MEMORANDUM

TO: Durham Conservation Commission, Durham Planning Board
FROM: Rick Taintor, Consulting Planner
DATE: November 18, 2020
RE: Mill Plaza Redevelopment – Update on Proposed Impervious Surface Areas

**Mill Plaza
Redevelopment**

SITE PLAN	
SCALE:	AS SHOWN
C-102

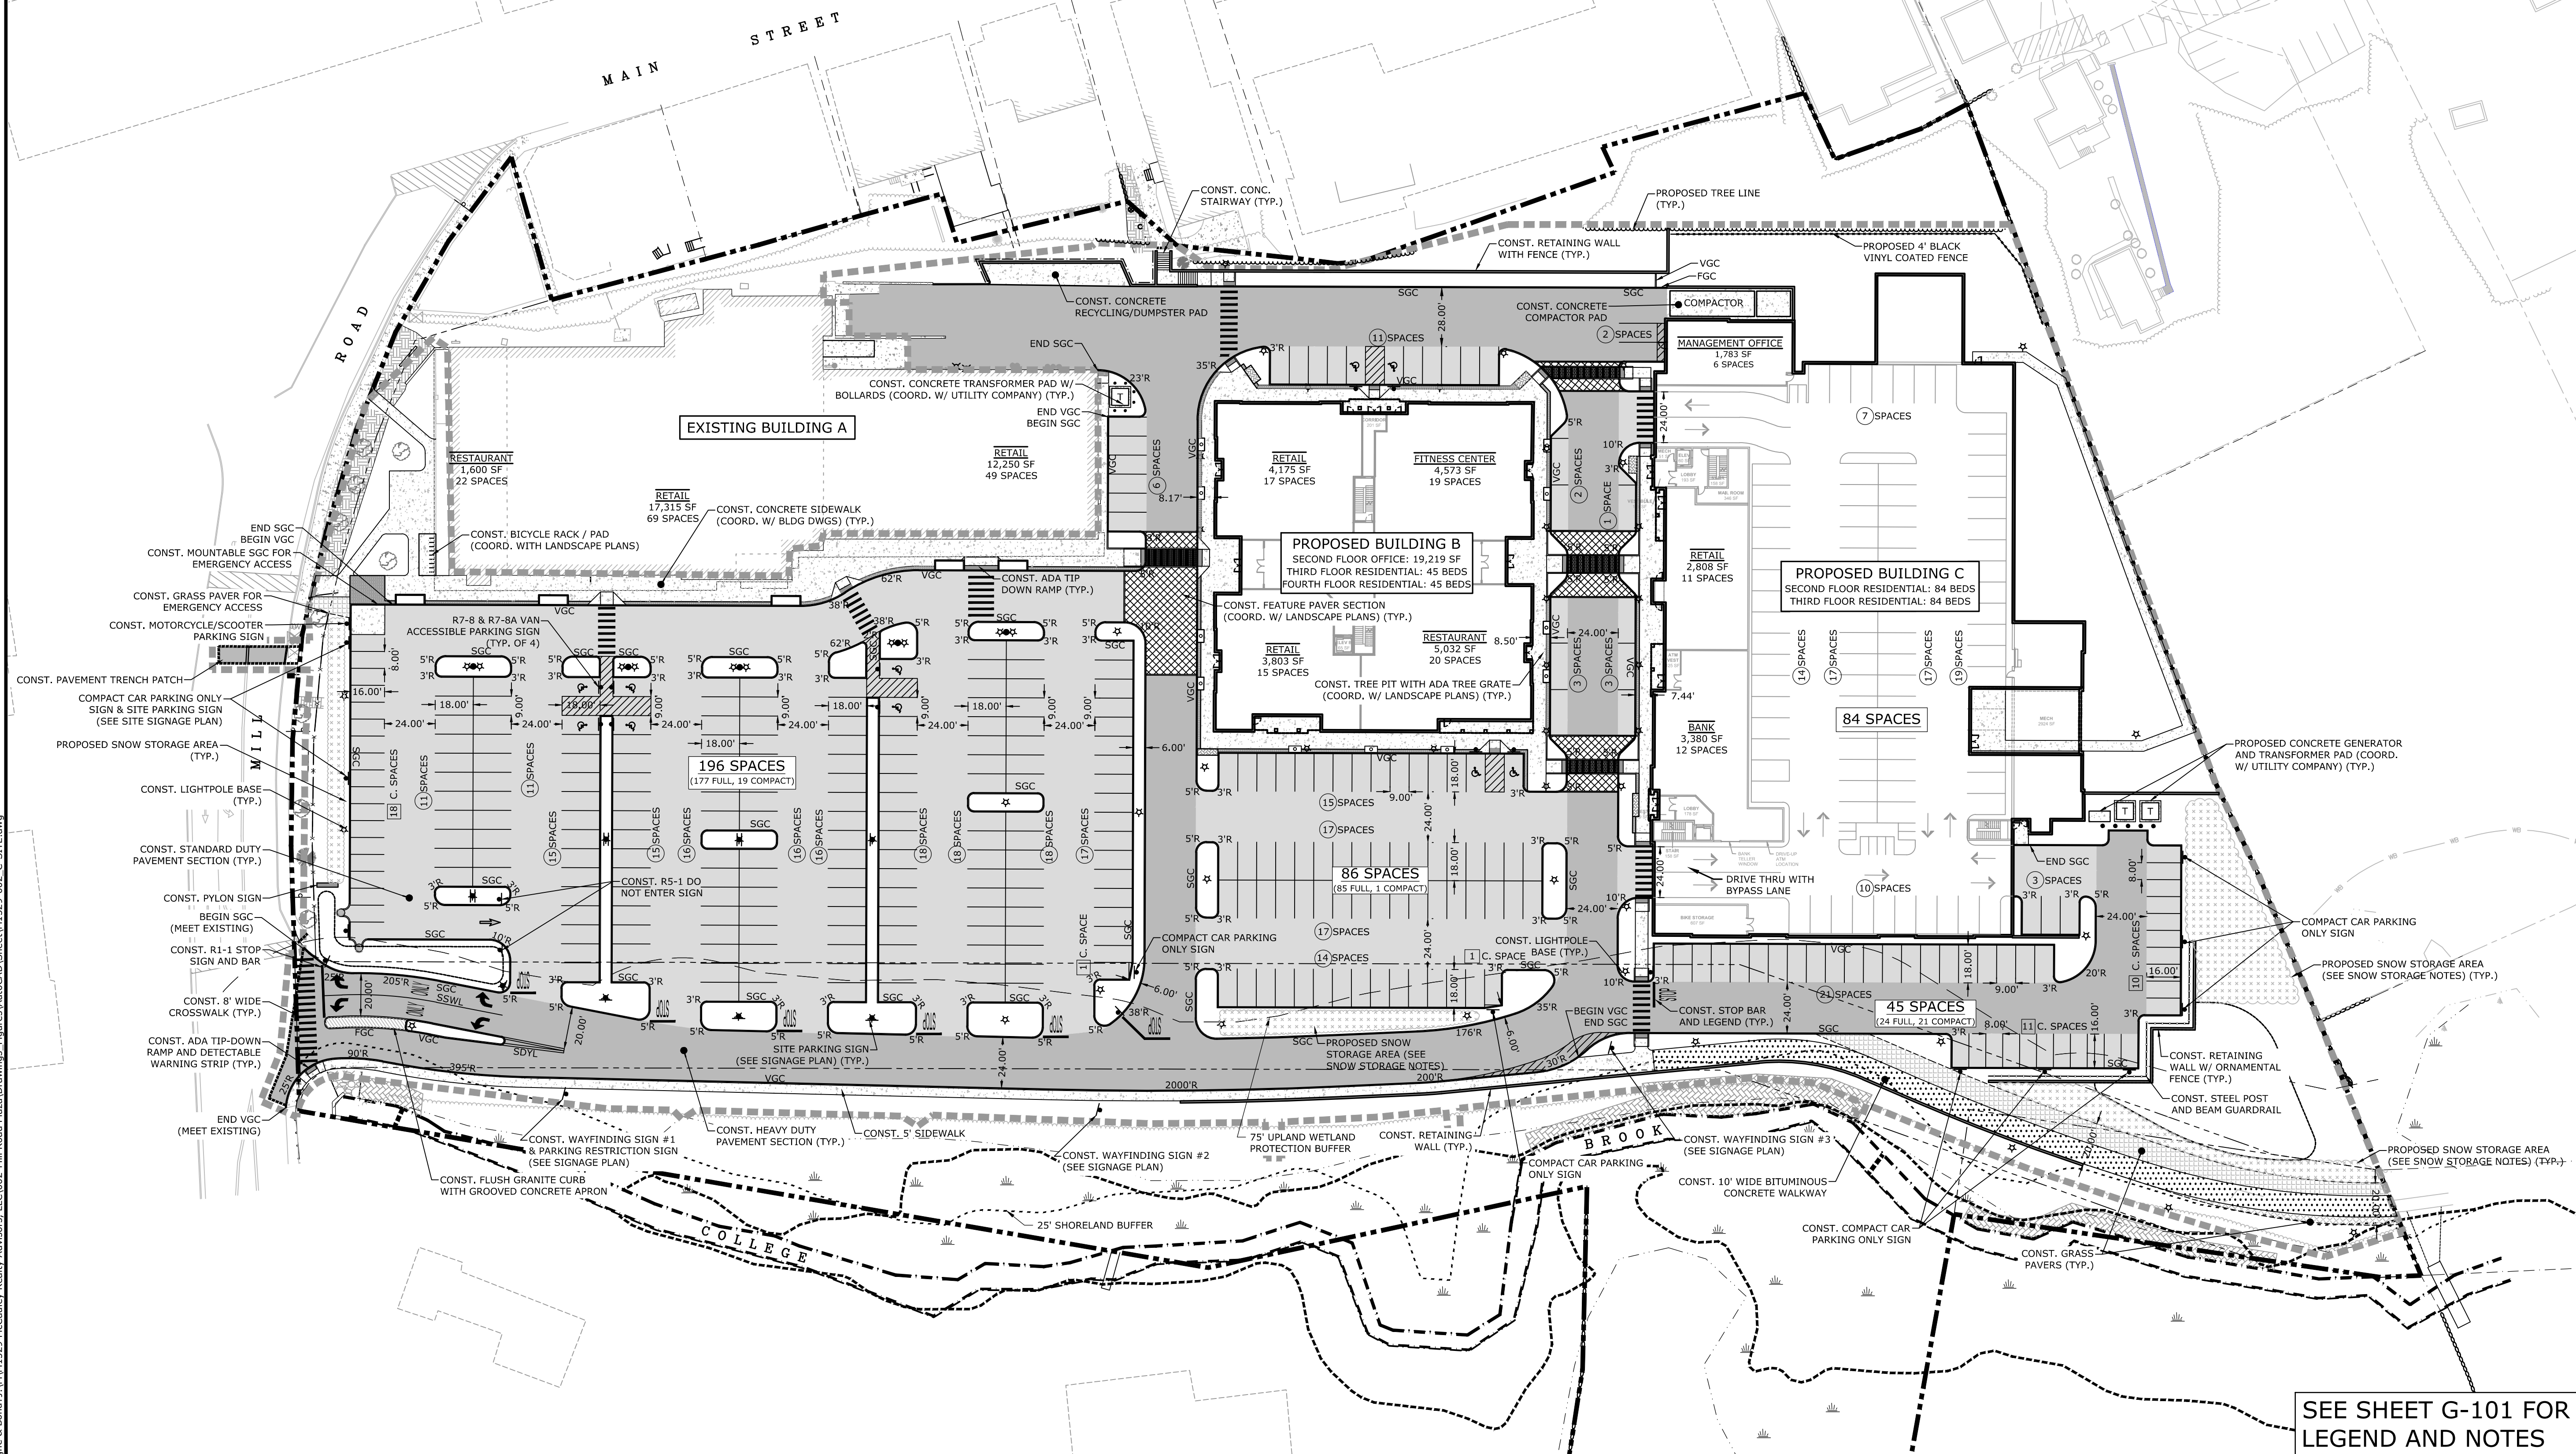
- An updated Site Plan (Sheet C-102) correcting the data for projected impervious cover (see clouded area in upper left). The updated plan indicates that the total proposed impervious cover on the parcel is slightly less than shown on the January plan due to the addition of landscaped islands in the parking area in front of Hannaford.

AREA CALCULATIONS:		
IMPERVIOUS (SF)	EXISTING 275,734	PROPOSED 290,095
EFFECTIVE IMPERVIOUS COVER (SF)	275,734	8,163

PRE- VS. POST-DEVELOPMENT
SURFACE COMPARISON

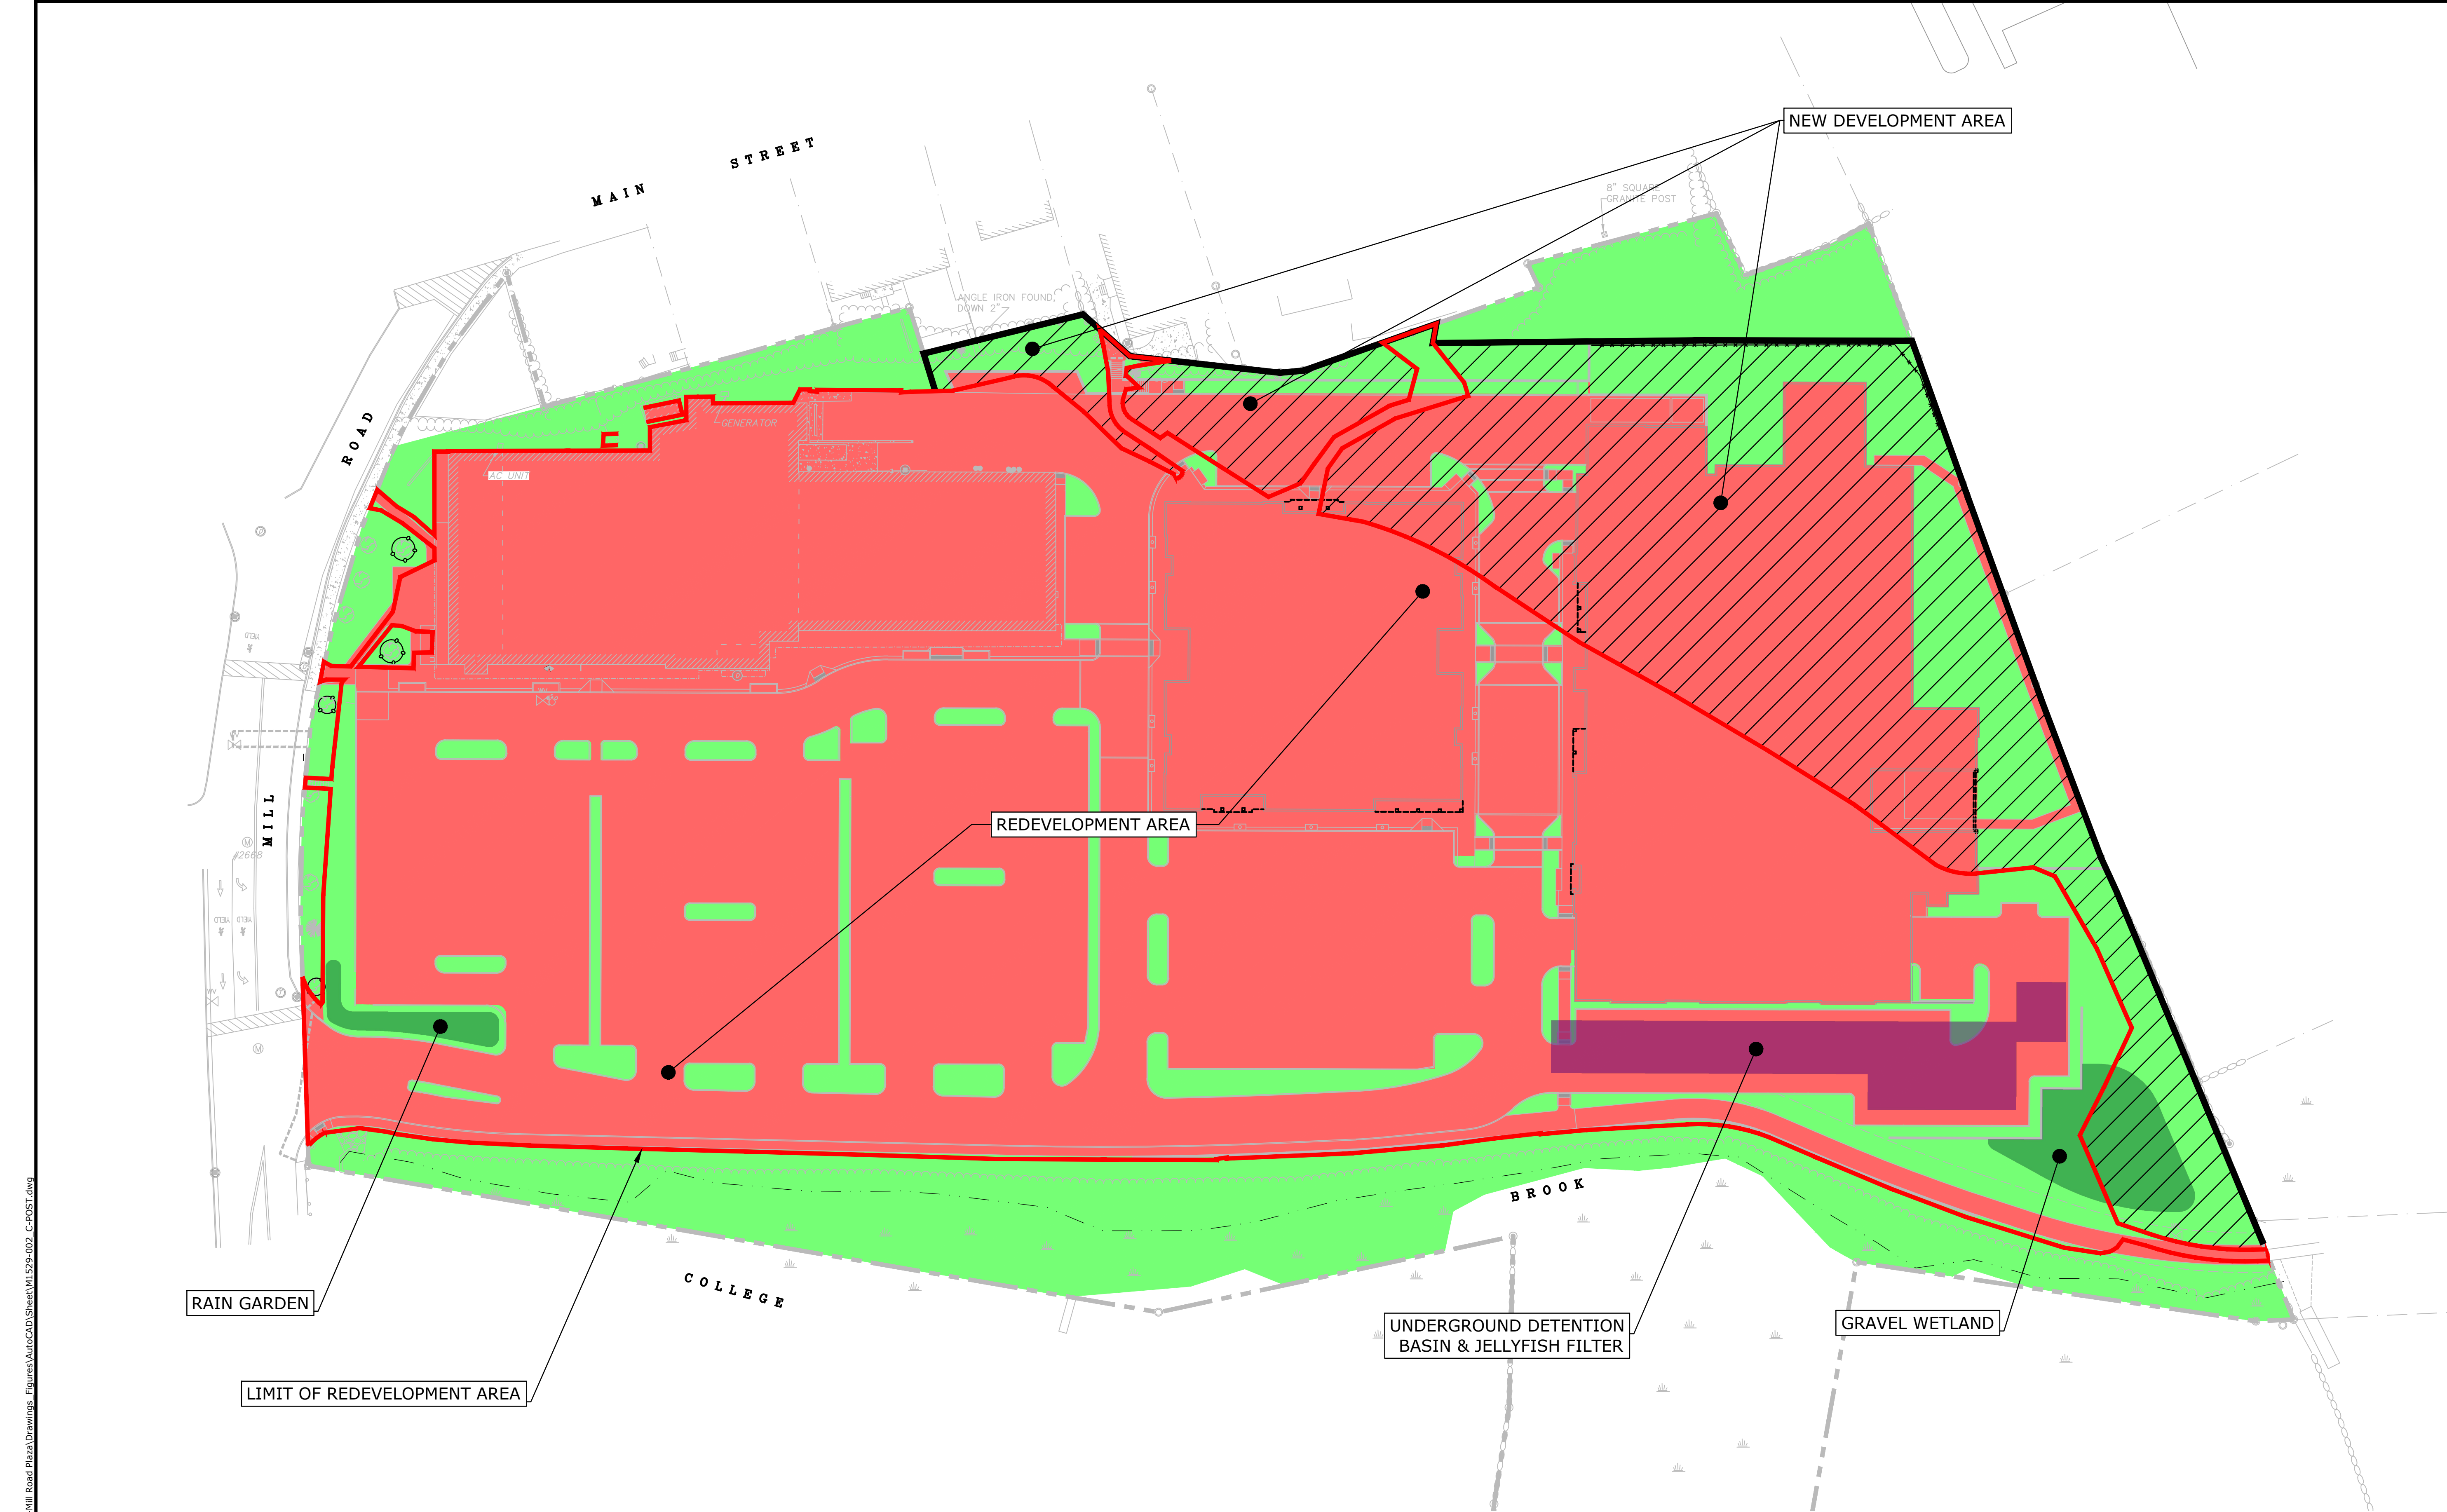
- An updated “Pre- vs. Post-Development Surface Comparison” plan stating the existing (pre-development) and proposed (post-development) impervious surface areas on the site. These impervious surface areas are shown separately for the “Redevelopment Area” (i.e., the existing developed area of the parcel, outlined in red on the plan) and the “New Development Area” (the currently undeveloped, vegetated area along the northeast and east perimeter of the parcel, shown by a black hatching). This plan is an update of the “Surface Area Treatment Plan” contained in the applicant’s 5/20/2020 response to the initial stormwater peer review (see the file on the project web page entitled “Supporting Documentation 5-20-20”).
